HOPE CREEK GENERATING STATION  
DOCKET NO. 50-354  
DRAFT SAFETY EVALUATION REPORT  
OPEN ITEM STATUS

DSER Open Item 176d (Section 14.2)

COMMENTS ON LAWRENCE LIVERMORE NATIONAL LABORATORY REPORT

Reference: "Draft Report: Site Spectra for the Hope Creek Site", prepared by the Lawrence Livermore National Laboratory (LLNL) for the NRC, July 16, 1984. -

Figure 1 Soil Column for Evaluation of Hope Creek Site Spectra

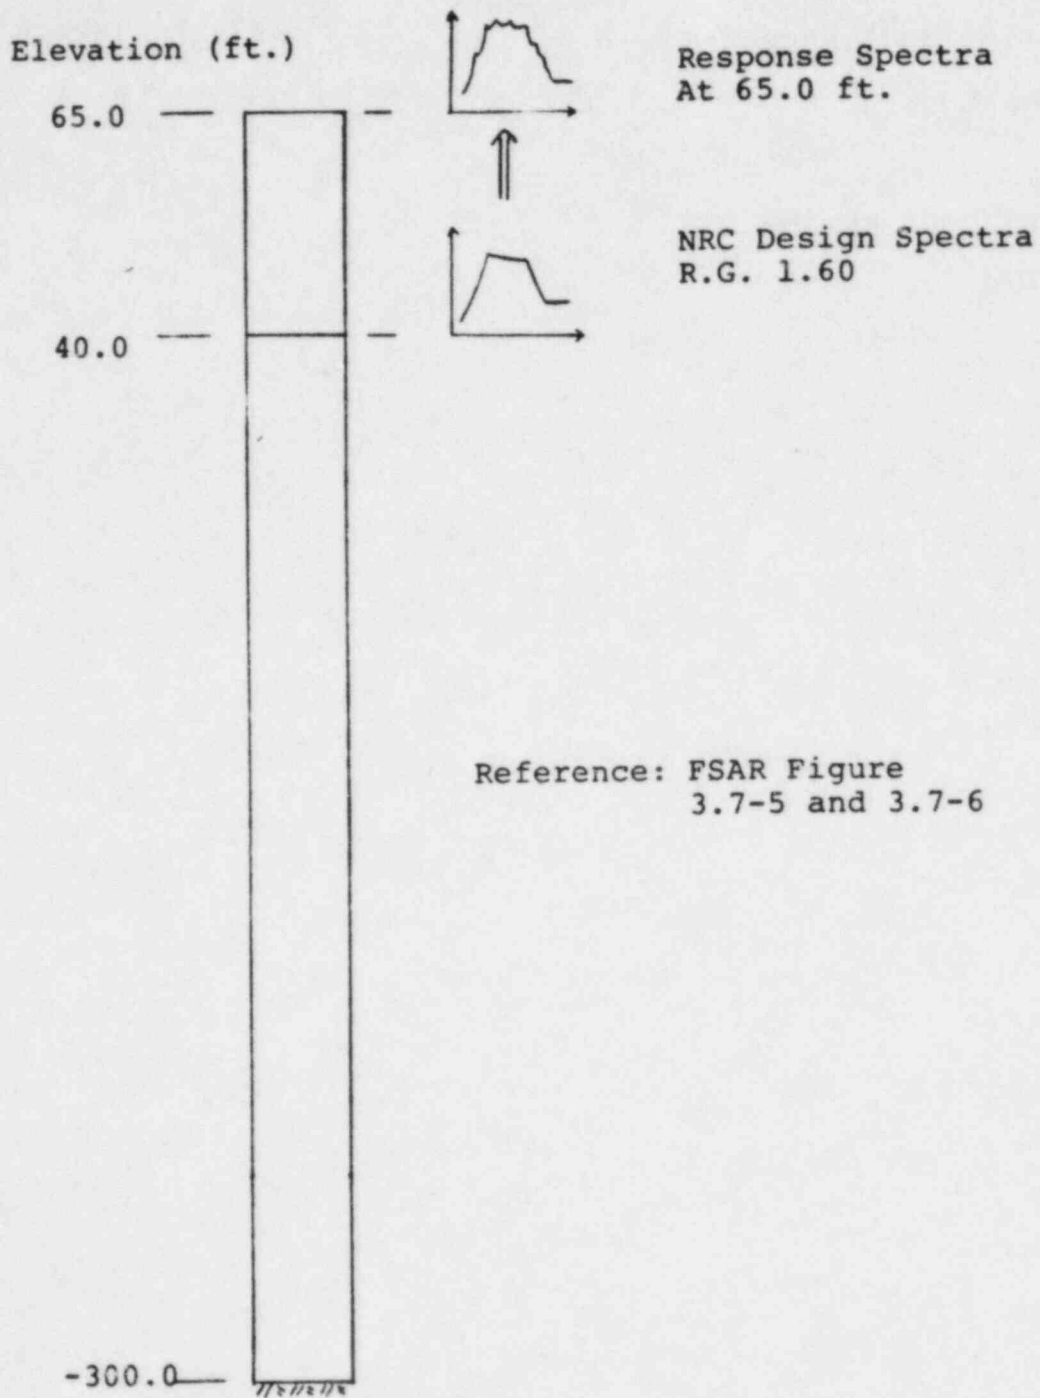
- i. A free-field soil column as shown in Figure 1 is used in deconvolution analysis. The top of the soil column is truncated at elevation 65.0 ft since the soil below this elevation (Kirkwood and Vincentown formation) has shear wave velocity of approximately 1,850 ft/sec which are comparable to the site condition of the LLNL Study. FLUSH computer code is used for the soil column analysis (Reference 2).

- i. The soil column as shown in Figure 1 is used for the evaluation of the Hope Creek vertical site spectra. Due to the presence of water table near the ground surface, the compression wave velocity of soil is appropriately adjusted for the vertical analysis.

**FIGURE 2A**  
 RESPONSE SPECTRA COMPARISON  
 AT TOP OF FREE FIELD  
 HORIZONTAL, SSE, 5% DAMPING

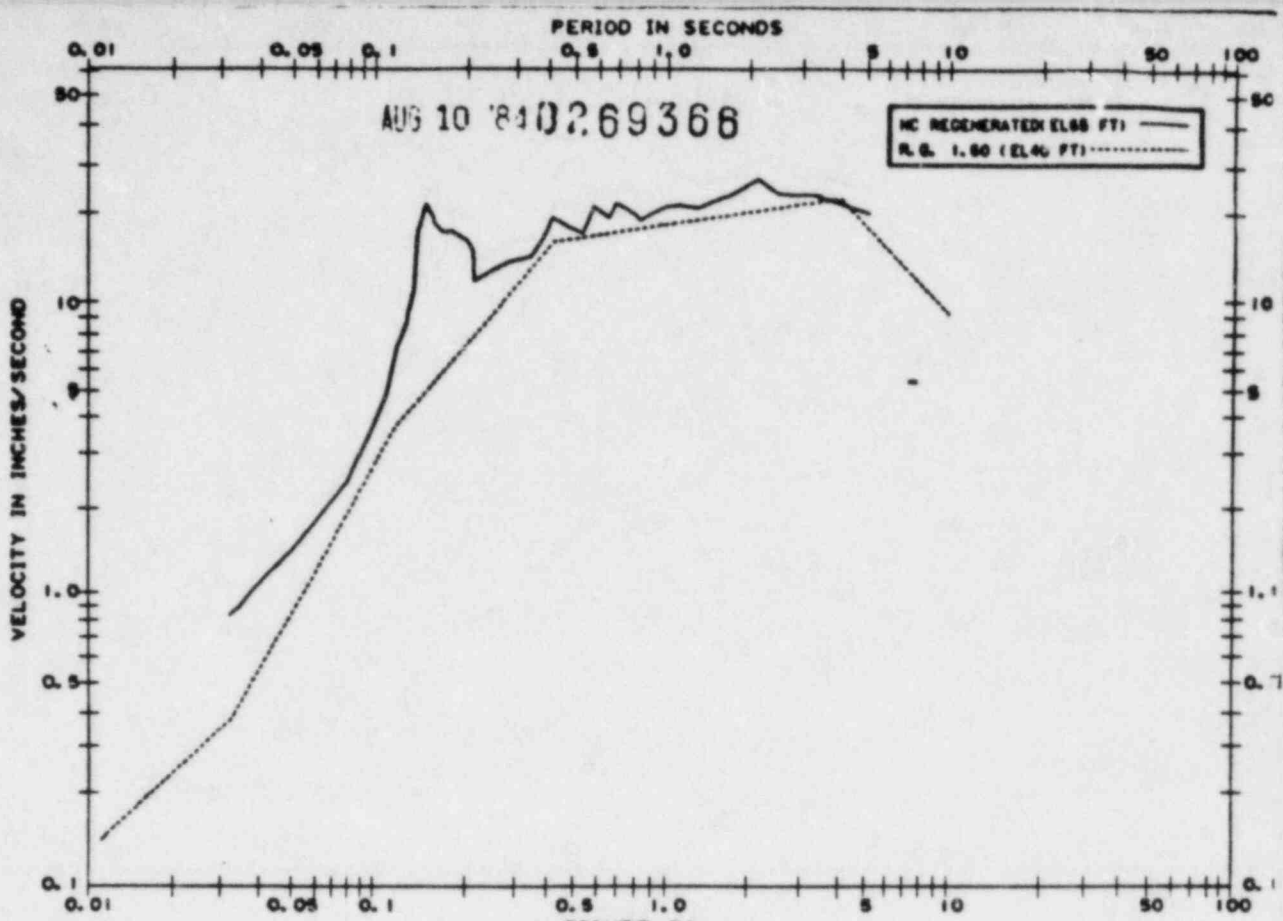
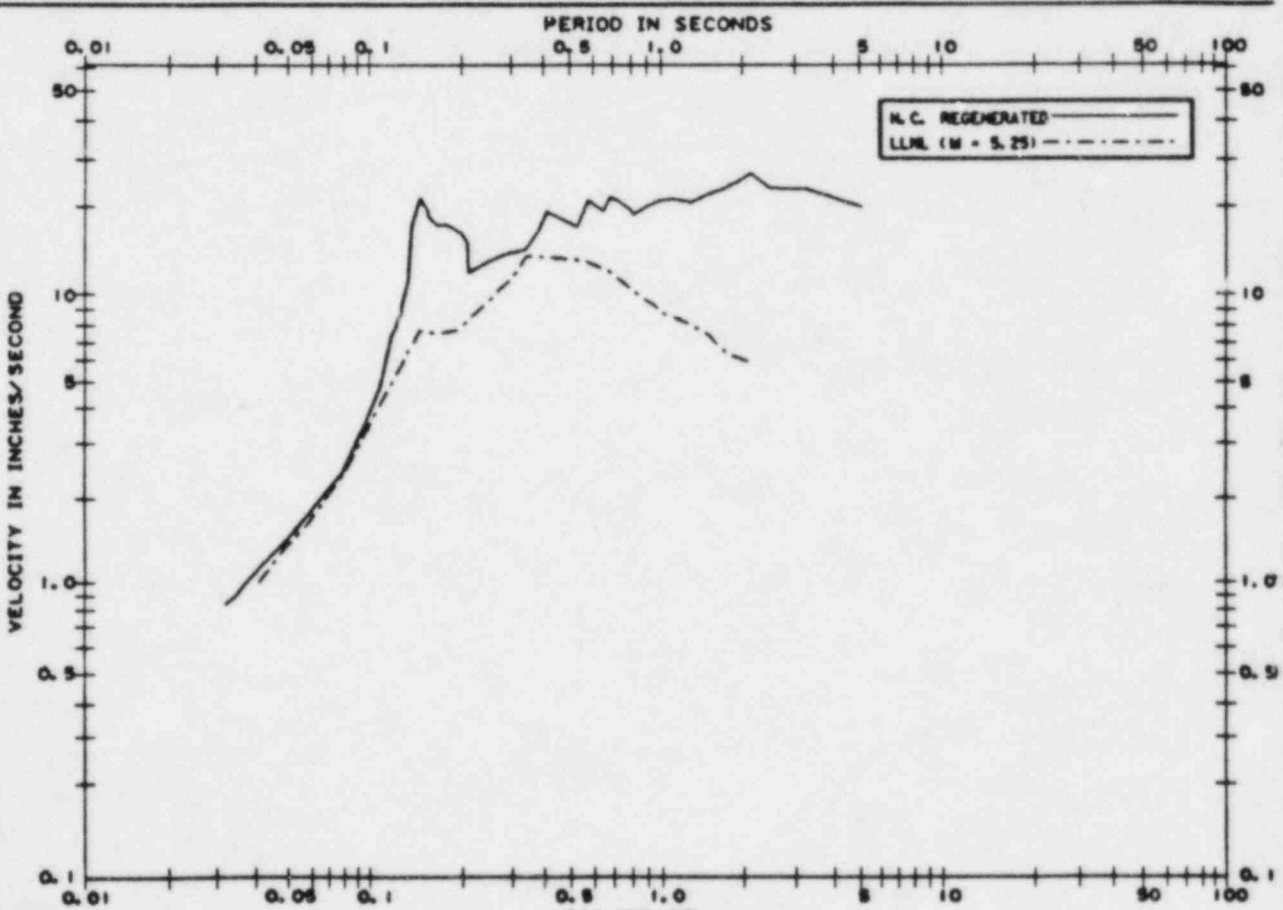
- ii. The Hope Creek design spectra are applied at elevation 40.0 ft where the power block foundation is located and the response spectra (5% damping) at the top of the soil column are generated. Figure 2A shows the comparison plots between the regenerated spectra at the top of the soil column and the input spectra delineating amplification effect. Figure 2B shows comparison between the LLNL spectra ( $m_b L_g = 5.25$ ) and the regenerated design spectra.

FIGURE 3A  
 RESPONSE SPECTRA COMPARISON  
 AT TOP OF FREE FIELD  
 VERTICAL, SSE, 5% DAMPING

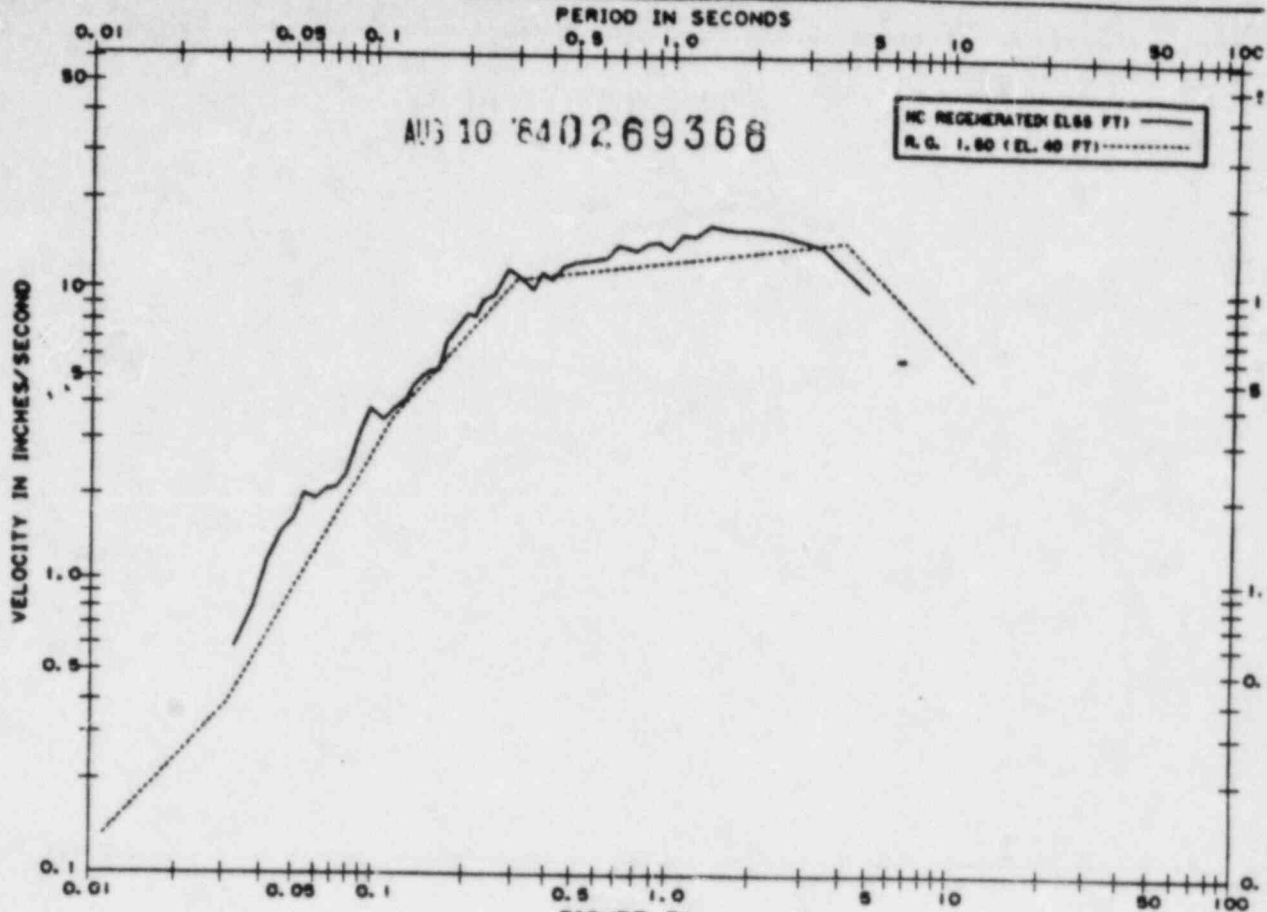
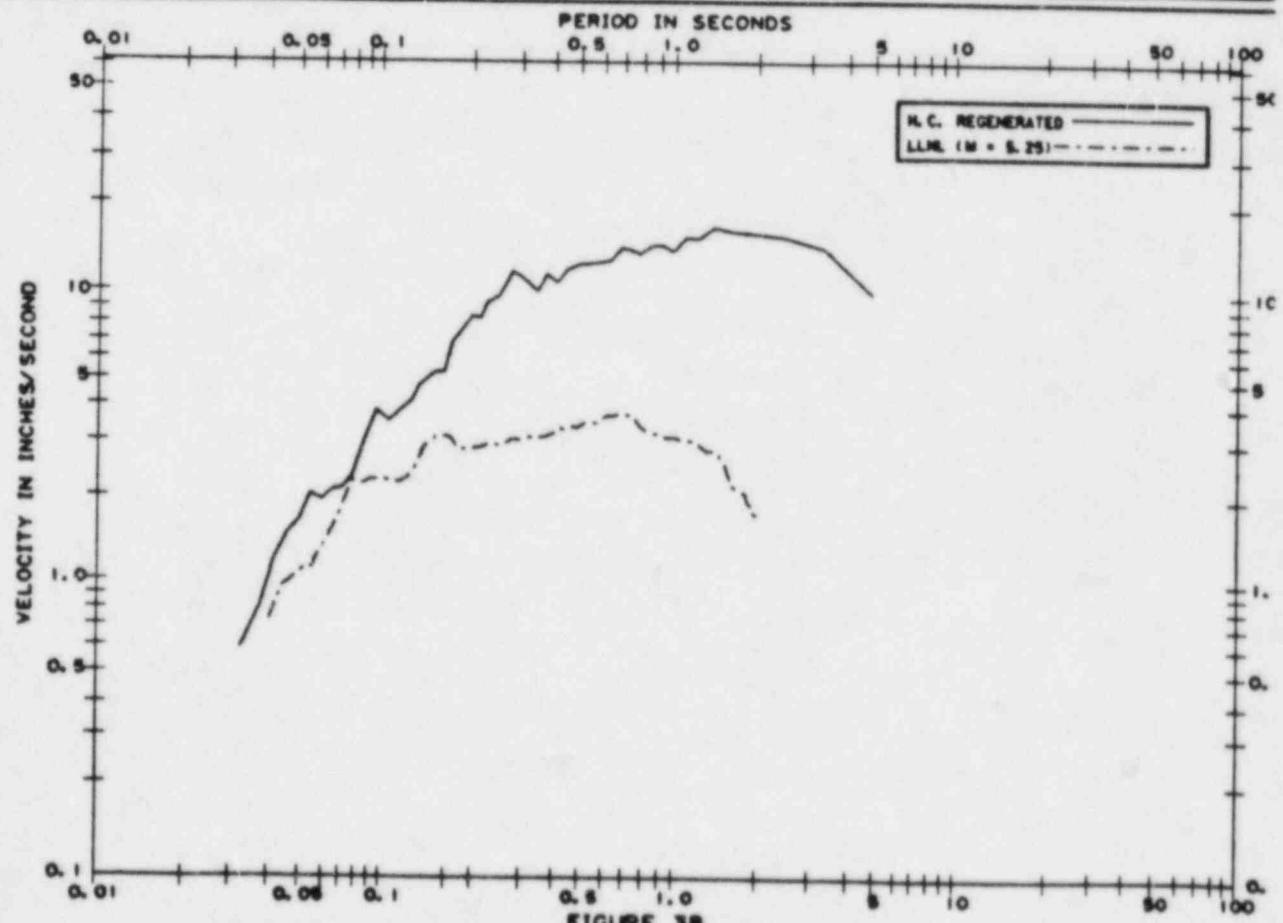
- ii. The Hope Creek design response spectra are applied at elevation 40.0 ft of the soil column and the corresponding response spectra are regenerated at elevation 65.0 ft.
- iii. Figure 3A shows the comparison plots between the velocity response spectra at the top of the soil column and the input spectra delineating amplification effect. Figure 3B provides the comparison between LLNL spectra and the equivalent regenerated Hope Creek spectra. The Hope Creek spectra envelop the LLNL spectra. Therefore, it is concluded that the Hope Creek input spectra are adequate.
